49-51 YORK STREET

AP- 51 York Street

Permit to construct a 1-story concrete block addition 52'x36' on rear of building as per plans to be used as a repair garage and sheet metal work is being approved subject to a discussion with your representative, Mr. Conley, and your letter of July 26, 1963, and as follows:

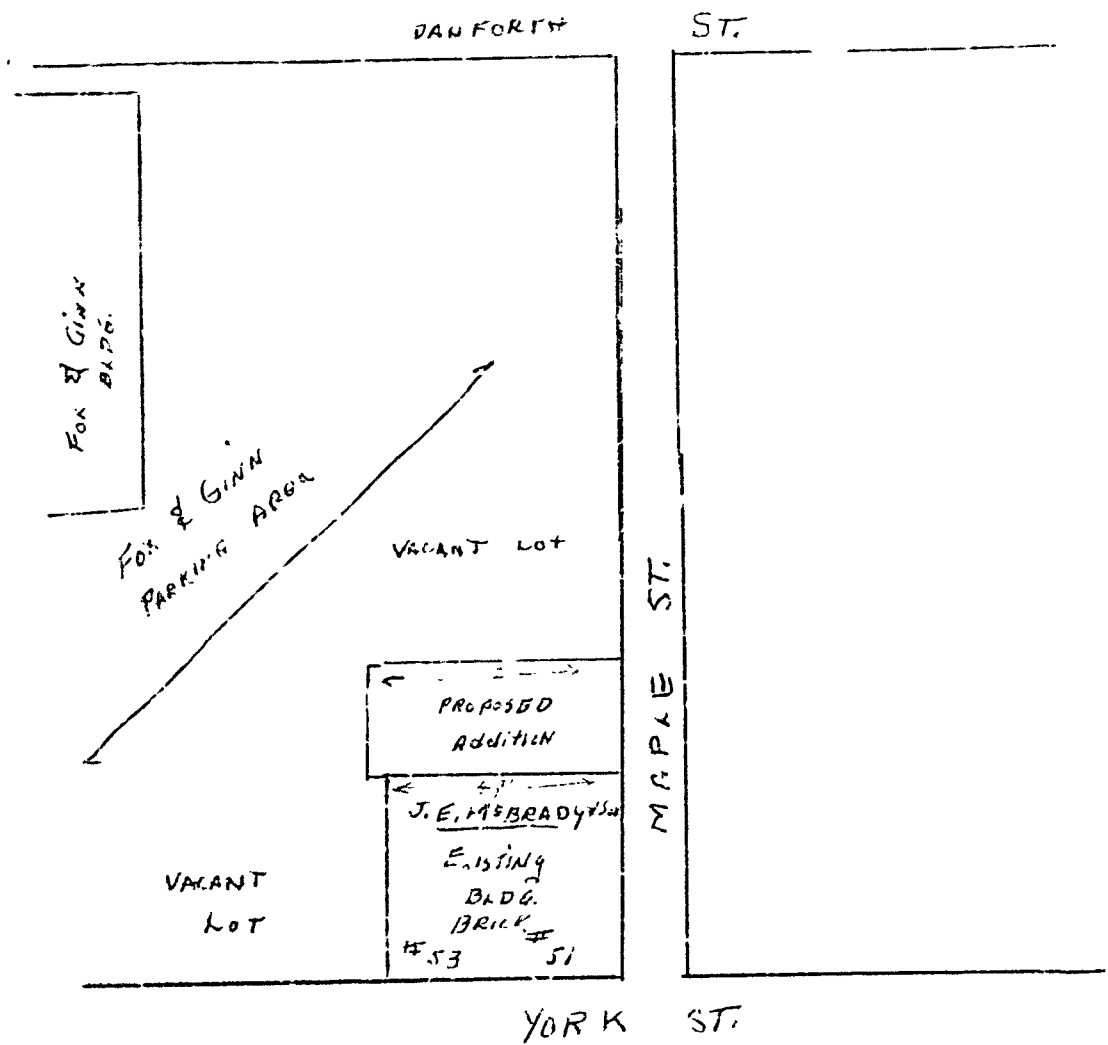
- 1- No off-street parking requirements for garages under zoning ordinance
- 2- How are required means of egress serving existing 3-story building affected by addition, bearing in mind practically that the lot is being occupied?

- 3- Section 212-e-12(a) requires required exits to discharge to the open air at ground level on open spaces or spaces of land controlled by owner of building or structure. Since addition is to be built on lot lines, how is required means of egress to be provided from rear of building?

- 4- If roof is to be of incombustible material, does not Section 303-b-1 allow omission of parapets?
- 5- Does not Section 212-b-2 require a two hr. separation between garage and existing building?

- 6- What about enclosure of heater if not ^{approved} suspended?
- 7- What about separate rooms for forges, vulcanizing and other heat generating apparatus other than central heating plants or unit heaters?

- 8- Fire-proofing of lintels over garage door openings required if masonry above them is more than 4 feet high
- 9- Unreinforced concrete wall projects 4' above grade. Should this not be limited to 3'?

J. E. Mc BRADY & SON INC
 51 YORK ST. PORTLAND
 APPROX. WGT OF SIGN 200 LBS
 SCALE 1/4" = 1'-0"

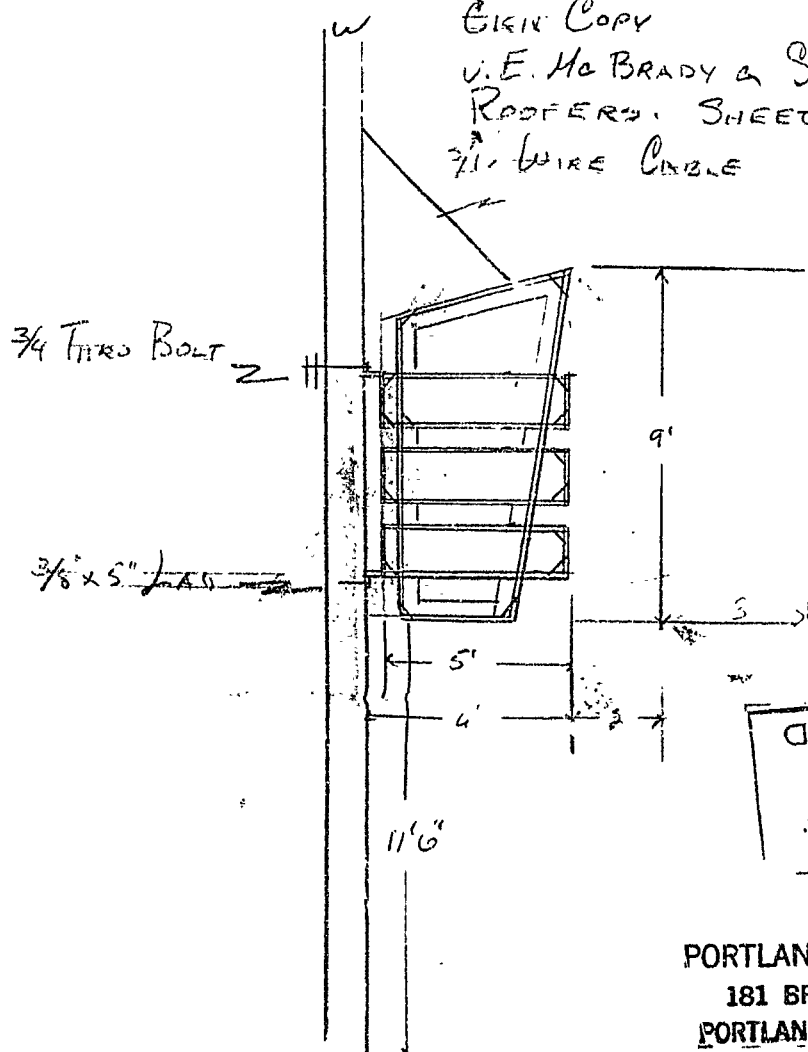
5/9/58 plastic faces
were not stamped.
Wires were not fully enclosed.
J.E.B.

6/10/58 - Wals done,
sign being J.E.B.
